date: April 4, 2024
to: Jennifer Hofmeister-Drew, AICP, LCAM, Planner III,
Town of Palm Beach
from: Eric Czerniejewski, P.E., ENV SP
subject: Paramount Palm Beach Traffic Review

MEMORANDUM

The Corradino Group, Inc (Corradino) has been requested to provide a traffic review of the Traffic Impact Evaluation for the redevelopment of the Paramount Theatre located at 139 North County Road in the Town of Palm Beach, Florida. The following are our traffic review comments based on the 03/12/24 resubmittal.

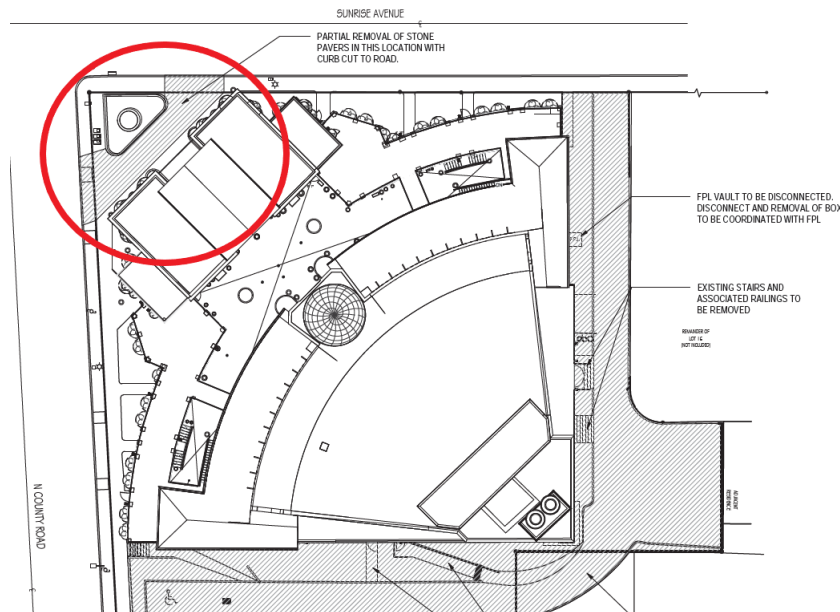
12. Please provide additional narrative that provides the total amount of queuing available from the valet stand to the adjacent road network for both scenarios. Figures 3 and 4 should be updated to denote the total amount of queuing available from the valet stand to the adjacent road network.

Kimley Horn and Associates, Inc.'s 03/09/23 Response Additional information is provided in the updated report and Figures 3 and 4 illustrating the queuing available to the adjacent road network. Note that the valet stand for the event space is proposed to be located on North County Road.

Figure 212.11.1 Clear Sight Triangles

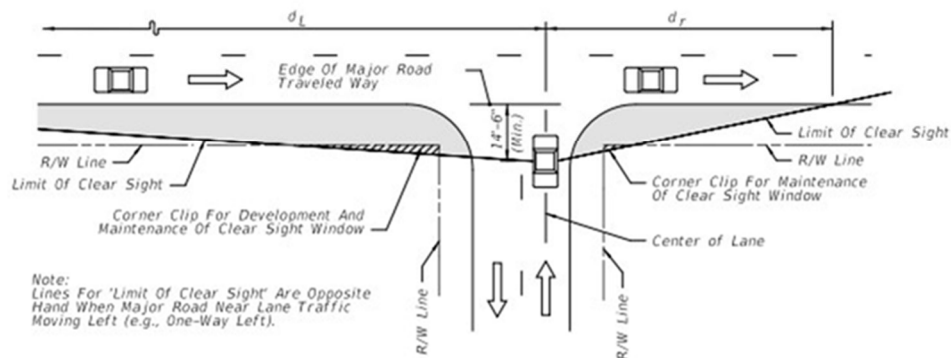
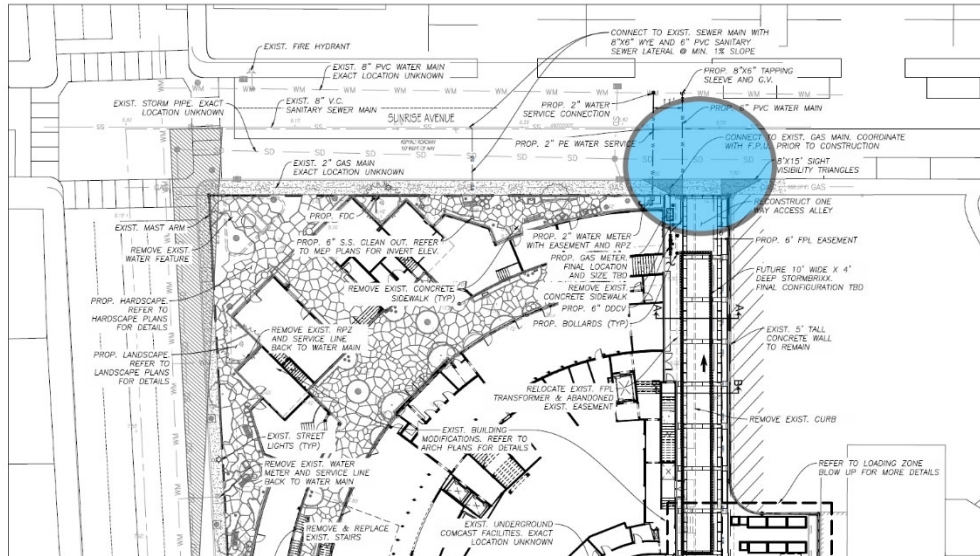
49. Please provide sight visibility triangles on the site plan at each of the driveway connections. The sight triangles should also be depicted on the landscape plans and the pavement marking and signage plans. This includes evaluation of the sight distance at the egress only driveway connection to Sunrise Avenue. The sight triangles along NE 163rd Street/SR 826 should meet FDOT criteria as outlined in the FDOT Design Manual (Section 212.11). Please update these sight triangles accordingly
